Reply to RC3: 'Comment on hess-2022-330'

This manuscript deals with the modelling of shallow groundwater flows and levels in urbanized catchments, and highlights the impact of both the urban geology description and the spatial resolution used in the distributed model. This topic is of high interest, because the interactions between groundwater and underground constructions are important in urban soils whose features are very variable, and we need to improve our ability to simulate these complex hydrological behaviours.

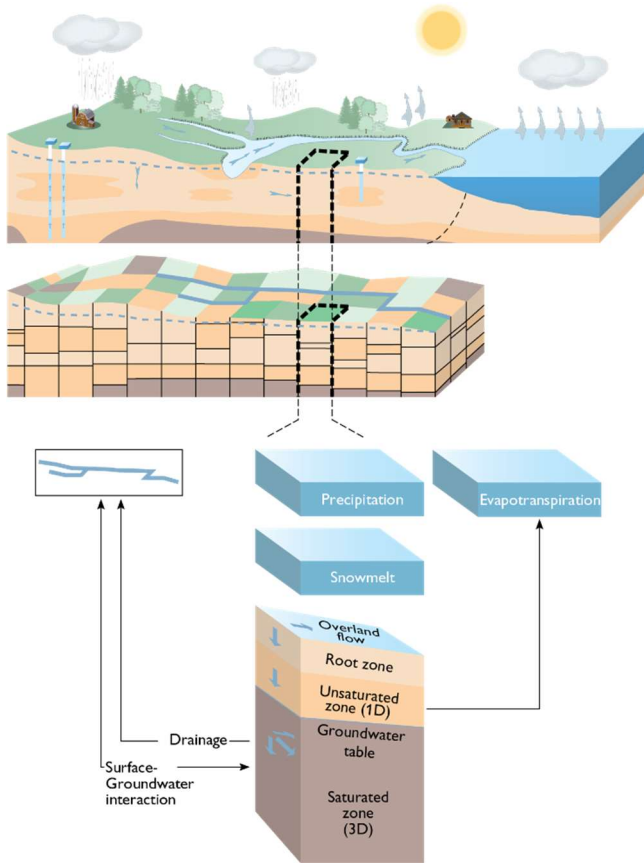
Then, the methods section could have been improved with a graphical scheme helping the reader to understand the chosen parametrizations. This is especially needed in the 3.2.2 paragraph, because the list of the presentation of the parametrization and boundary conditions is quite long, and a scheme would be more efficient and more easy for the reader.

Reply: *The parameterization is indeed complicated. Some parameters are defined from data, some were specified from past model experience and some were subject to calibration as described in section 3.3.*

To enhance the readability of the parameterization we suggest to expand the revised manuscript with either an additional table or a figure.

A figure could be an illustration of the model setup such as below with an additional description of the reduced infiltration (the surface-subsurface leakage coefficient), the overland drainage component, and leaking sewers:
